REMARKS

Claims 1, 2, 5, 7-10, 12-17, 19-23, 27, and 28 stand rejected under 35 U.S.C. § 102(b) as being anticipated by U.S. Patent No. 3,147,822 to Watts. Claims 3 and 6 stand rejected under 35 U.S.C. § 103(a) for obviousness over the Watts patent. Claims 4, 11, and 18 stand rejected under 35 U.S.C. § 103(a) for obviousness over the Watts patent in view of U.S. Patent No. 2,489,182 to Huck. In response, Applicants have amended claims 1, 9, 14, 15, 17, and 23. In view of these amendments and the following remarks, Applicants traverse the rejections.

FIG. 6

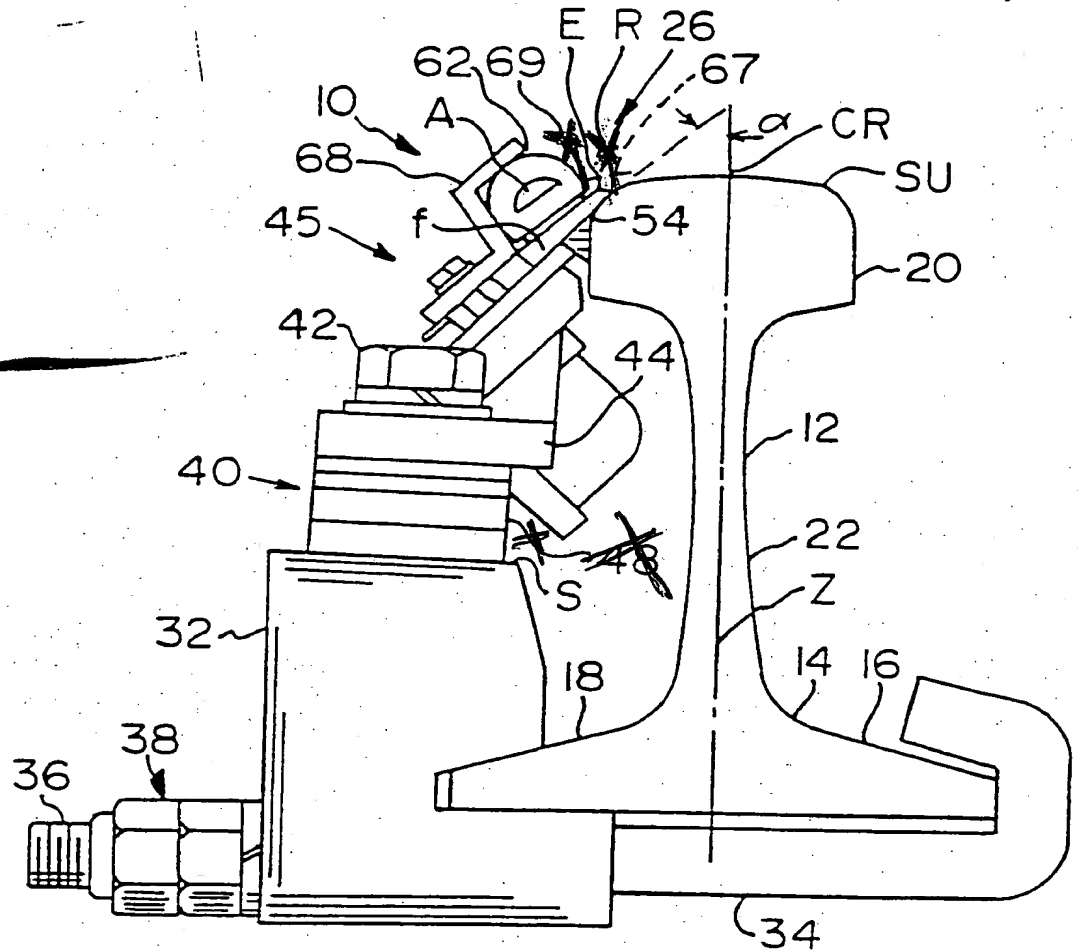
*Proposed change
 in red and yellow highlight*

FIG. 5

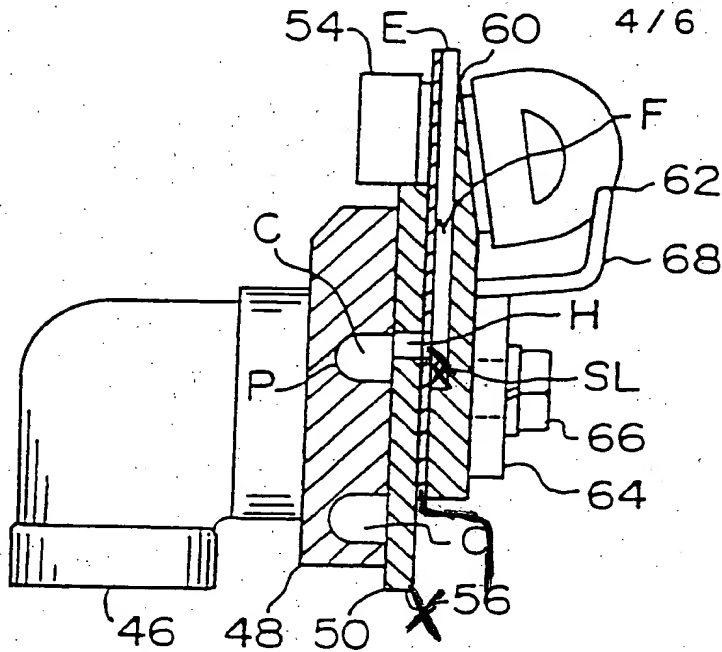
The drawings stand objected to for various informalities. Specifically, two reference numerals 48 have been included in the drawings related to the manifold and spacers. In response, the reference character 48 has been eliminated. The spacers have been identified as reference character 40. Likewise, the specification has been amended to identify the spacers as reference character 40. Figs. 2 and 5 have been amended to correct lead lines.
